Consolidated Edison Company of New York, Inc.
4 Irving Place, New York, N Y 10003
Telephone (212) 460-3819

March 8, 1976

Re Indian Point Unit No. 3
Docket No. 50-286

A listing of those electrical schematics affected by these changes is delineated in Attachment A. Forwarded herewith are seven (7) copies of finalized versions of those schematics listed in Attachment A.

Westinghouse Electric Corporation	
TITLE: CONSOLIDATED EDISON CO	
INDIAN POINT STATION-UNIT #93	
ELEMENTARY WIRING DIAG	MOTOR OPERATED VALV
500B97	SHEET-140
ATOMIC POWER DIV., PITTSBURGH, PA.

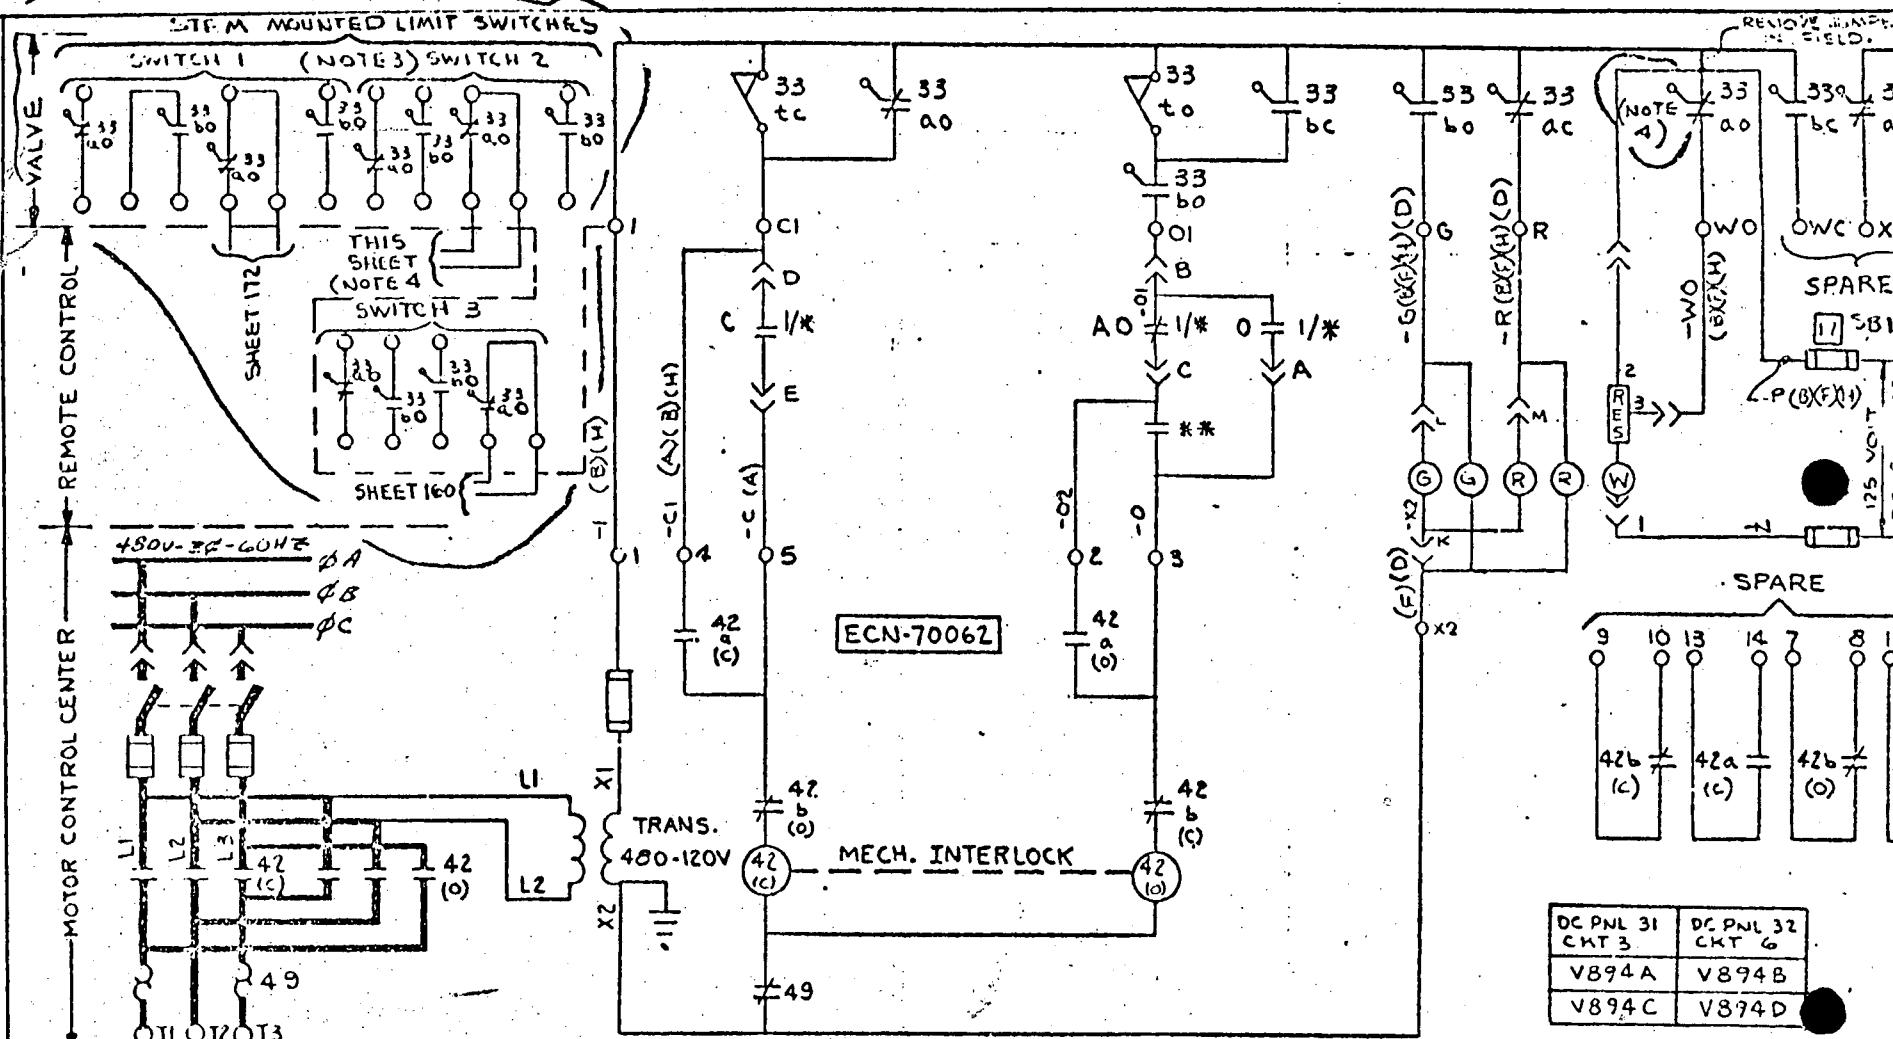
In addition, since the operator for Valve 894C is assumed to be submerged following a postulated loss-of-coolant accident, both its existing bright/dim white light circuit and annunciator alarm circuit which provides audible indication will be disconnected from the valve operator and reconnected to new limit switches mounted above the calculated water level (El. 50'-1½") inside containment. The limit switch for the new status light system is also mounted above the calculated water level. These new limit

4. USE 3340 ON STEM MTD. LIMIT SW. #2 FOR VLV. 894C.

- NOTE:
1. WIRE DESIGNATIONS ARE TO BE PREFIXED WITH VALVE NO.
 2. LETTER (A) ETC. REFERS TO CABLE SCHEMATIC.
 3. STEM MOUNTED LIMIT SWITCH #2 AND #3 ON VALVE 894C ONLY.

Westinghouse Electric Corporation	
TITLE: CONSOLIDATED EDISON CO.	
INDIAN POINT STATION- UNIT NO. 3	
ELEMENTARY WIRING DIAG. MOTOR OPERATED VAL	
500B97	
SHEET- 141	
ATOMIC POWER DIV.,	PITTSBURGH, PA. U.S.A.

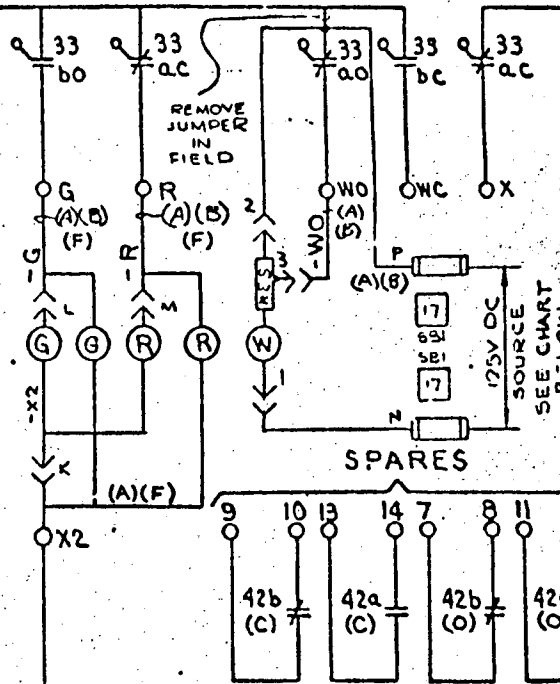
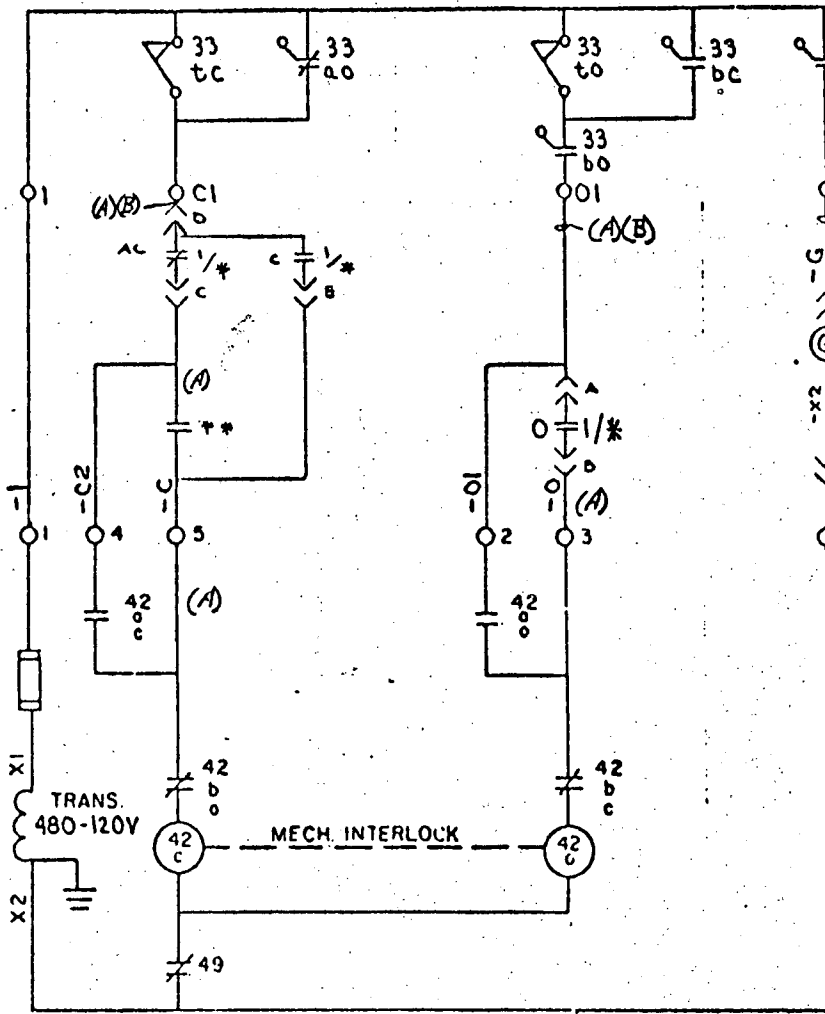
In accordance with NRC Branch Technical Position EICSB 18, the valves listed above will be provided with redundant position indication in the control room which in itself meets the single failure criterion. The existing indication systems will be supplemented with an independent status light system. The new status light system consists of separate limit switches mounted on each valve stem and cables routed in dedicated conduit separate from the existing raceway system. Within the control panel, the power supply (Circuit 8 on d.c. power panel 33) and the alarm chain will be routed in flexible ("sealtite") conduit into a spare module where the status light will be mounted.

Westinghouse Electric Corporation	
NUCLEAR ENERGY SYSTEMS, PITTSBURGH, PA., U.S.A.	
TITLE: CONSOLIDATED EDISON CO.	
INDIAN POINT STATION-UNIT 1	
S.I. VALVES POSITION LIGHT	
SCALE	500B97
DIMENSIONS IN INCHES	SHEET 172
DO NOT SCALE	SUB 1

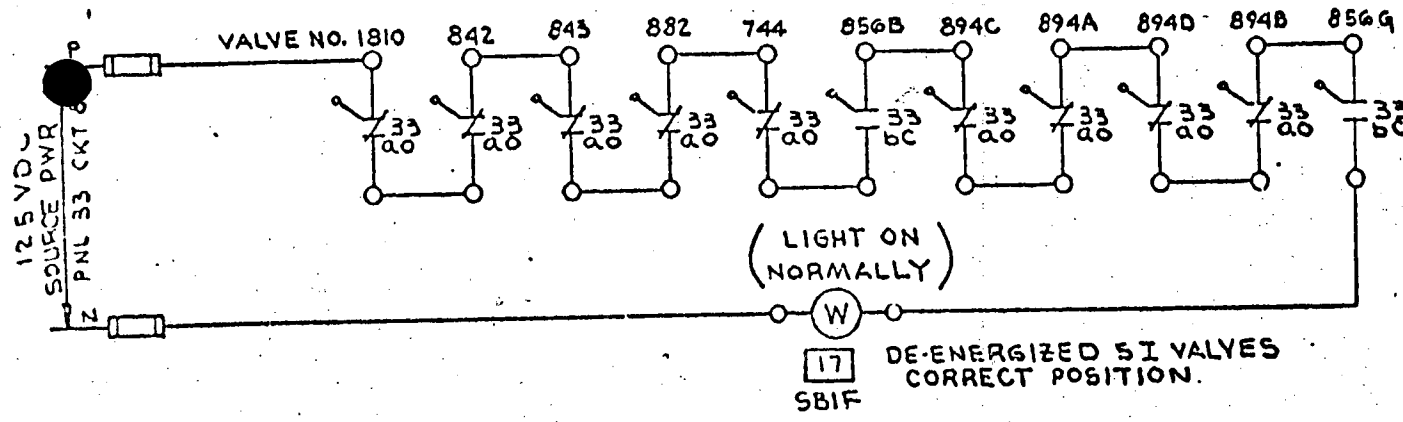
NOTE:
ALL LIMIT SWITCH CONTACTS FROM A STEM MOUNTED LIMIT SWITCH.
